**SPARC Enterprise M3000/M4000/M5000/
M8000/M9000 Servers**

Product Notes for XCP Version 1115

Part No.: E40564-03
April 2014

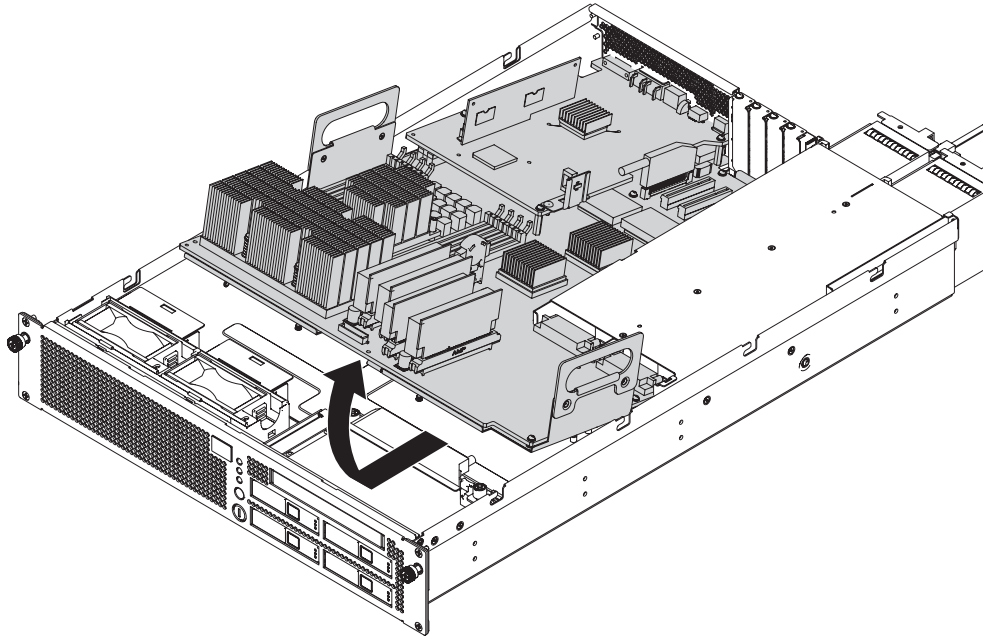
The figure below replaces Figure 6-5 in the *SPARC Enterprise M3000 Server Service Manual*. This corrected figure shows the daughter card installed on the MBU_A.

Title	Page Number	Update
<i>SPARC Enterprise M3000 Server Service Manual</i>	B-1	Table B-1 "FRU List" Footnote should be added: "Do not remove or swap non-FRU components such as MEMR and DDCs as this interferes with the repair depot's ability to diagnose and repair field returns." Figure 6-5 is corrected to show daughter card installed on the MBU_A.

Figure 1-13 shows the M9000 server (base cabinet) installation area.

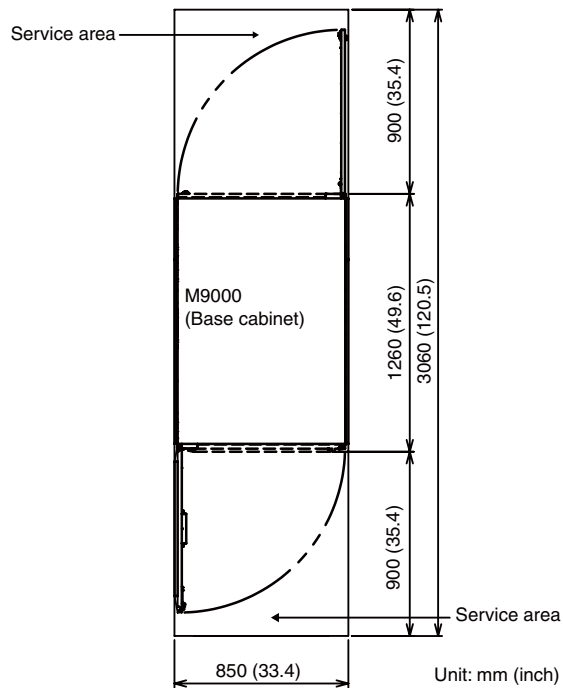
In the *SPARC Enterprise M8000/M9000 Servers Site Planning Guide*, Figures 1-13 – 1-16 required a correction to the metric conversion, 3060 mm (120.5 in.). The following illustrations show the corrected metric conversions.

<i>SPARC Enterprise M8000/M9000 Servers Site Planning Guide</i>	3-22	FIGURE 3-9, A warning label was attached to an M9000 server AC section to indicate a change in the terminal connection sequence.
	1-18- 1-21	FIGURES 1-13 – 1-16 have corrected metric conversion: 3060 mm (120.5 in.).
<i>SPARC Enterprise M8000/M9000 Servers Installation Guide</i>	3-32	FIGURE 3-28, A warning label was attached to an M9000 server AC section to indicate a change in the terminal connection sequence.
<i>SPARC Enterprise M8000/M9000 Servers Service Manual</i>	18-10	Step 10, Additional instructions were added regarding a warning label that was attached to an M9000 server AC section.

Warning Label on M9000 Server AC Section

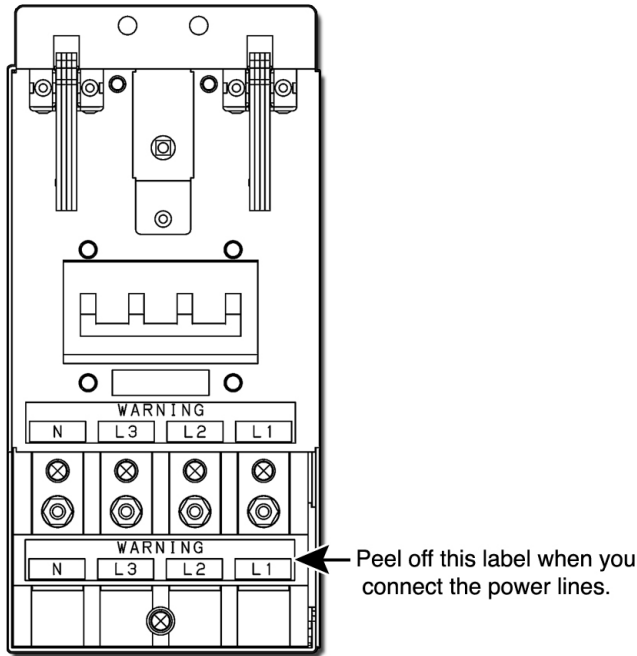
The warning label on the AC section indicates that the terminal connection sequence has been changed. Connect in accordance with the terminal sequence described on the warning label.
